Contract #: 04-0120F4Cty: SF/ALA Rte: 80 PM: 13.2/13.9File #: 69.25B**QUALITY ASSURANCE -- NON-CONFORMANCE REPORT****Location:** Changxing Island, Shanghai, PR China**Report No:** NCR-000787**Prime Contractor:** American Bridge/Fluor Enterprises, a JV**Date:** 06-Jul-2010**Submitting Contractor:** Zhenhua Port Machinery Company, Ltd (ZPMC), Changxing Island**NCR #:** ZPMC-0749**Type of problem:****Welding****Concrete****Other****Welding****Curing****Procedural****Bridge No:** 34-0006**Joint fit-up****Coating****Other****Component:** Doubler plate to Infill Plate**Procedural****Procedural****Description:****Reference Description:** Missed UT indication**Description of Non-Conformance:**

**Job Name:** SAS Superstructure  
**Document No:** 05.03.06-000745

**Reference Description:** Missed UT indication/Tower/Lift 2 Infill Plate

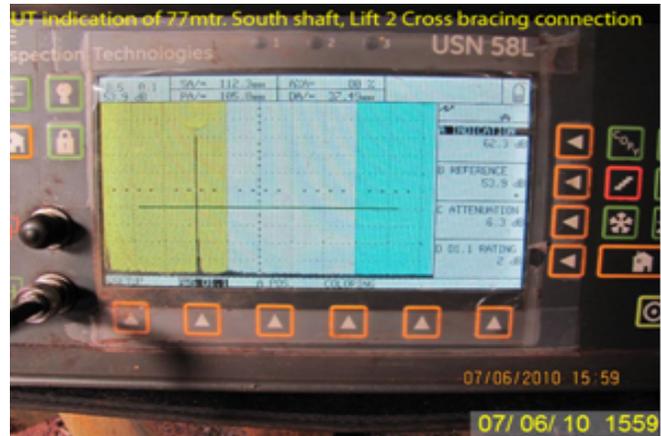
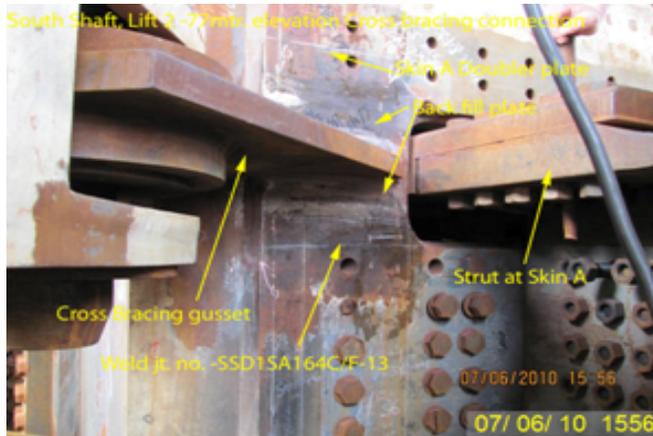
During random 10% verification of Ultrasonic Testing (UT) of Doubler Plate to Infill Plate, Quality Assurance Inspector (QA) discovered the following issues:

- One Class "B" non-conforming longitudinal indication measuring approximately 60 mm in length found in CJP weld between doubler plate and infill plate, at 77m level of South Shaft, Lift 2.
- The weld is identified as SSD1-SA164C/F-13.
- The discontinuity rating is Class "B" reject.
- Depth of the discontinuity is approximately 37mm from Face A, Y location found to be 15mm from Strut side.
- Material thickness is 50mm.
- The member is located in Tower Trial assembly(Lift2/Lift 3) area, Heavy Dock .

The Notice of Witness of Inspection is #006134. The indication is located within the area that has been previously tested and accepted by ZPMC Quality Control(QC)personnel.

Please refer to pictures below.

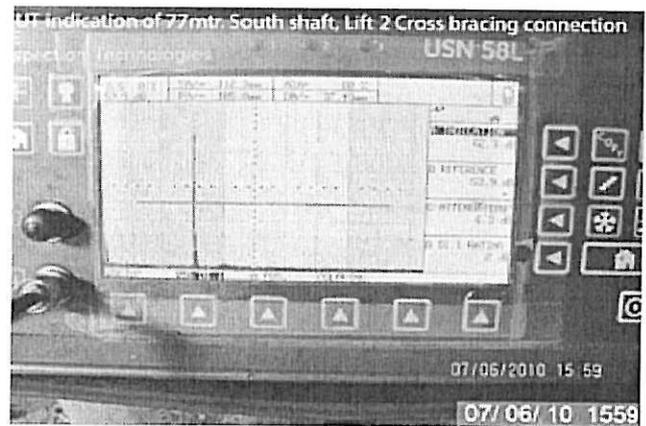
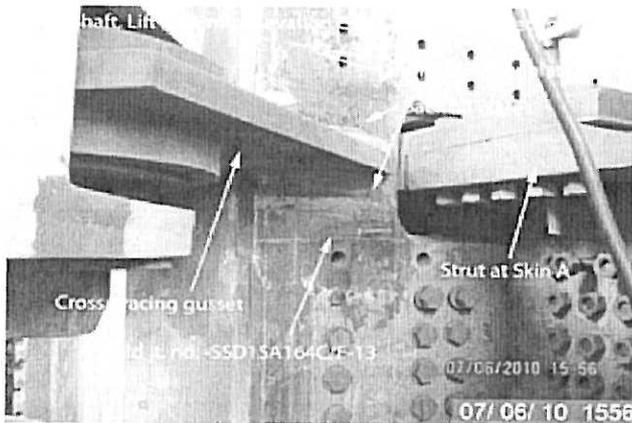
During random 10% verification of Ultrasonic Testing (UT) of Doubler Plate to Infill Plate, Quality Assurance Inspector (QA) discovered the following issues:

-One Class "B" non-conforming longitudinal indication measuring approximately 60 mm in length found in CJP weld between doubler plate and infill plate, at 77m level of South Shaft, Lift 2.

-The weld is identified as SSD1-SA164C/F-13.

-The discontinuity rating is Class "B" reject.

-Depth of the discontinuity is approximately 37mm from Face A, Y location found to be 15mm from Strut side.

- Material thickness is 50mm.

Please refer to pictures below.

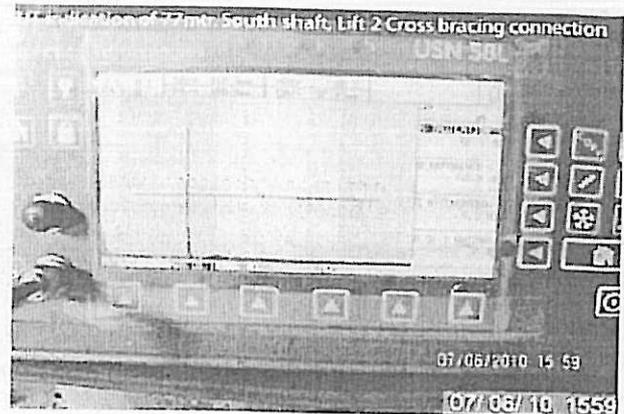
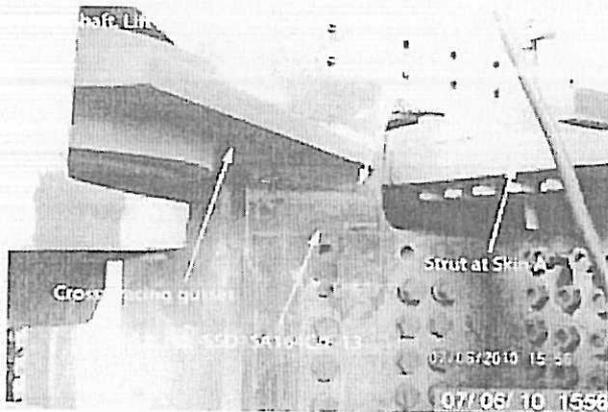
During random 10% verification of Ultrasonic Testing (UT) of Doubler Plate to Infill Plate, Quality Assurance Inspector (QA) discovered the following issues:

- One Class "B" non-conforming longitudinal indication measuring approximately 60 mm in length found in CJP weld between doubler plate and infill plate, at 77m level of South Shaft, Lift 2.
- The weld is identified as SSD1-SA164C/F-13.
- The discontinuity rating is Class "B" reject.
- Depth of the discontinuity is approximately 37mm from Face A, Y location found to be 15mm from Strut side.
- Material thickness is 50mm.
- The member is located in Tower Trial assembly(Lift2/Lift 3) area, Heavy Dock .

The Notice of Witness of Inspection is #006134. The indication is located within the area that has been previously tested and accepted by ZPMC Quality Control(QC)personnel.

Please refer to pictures below.
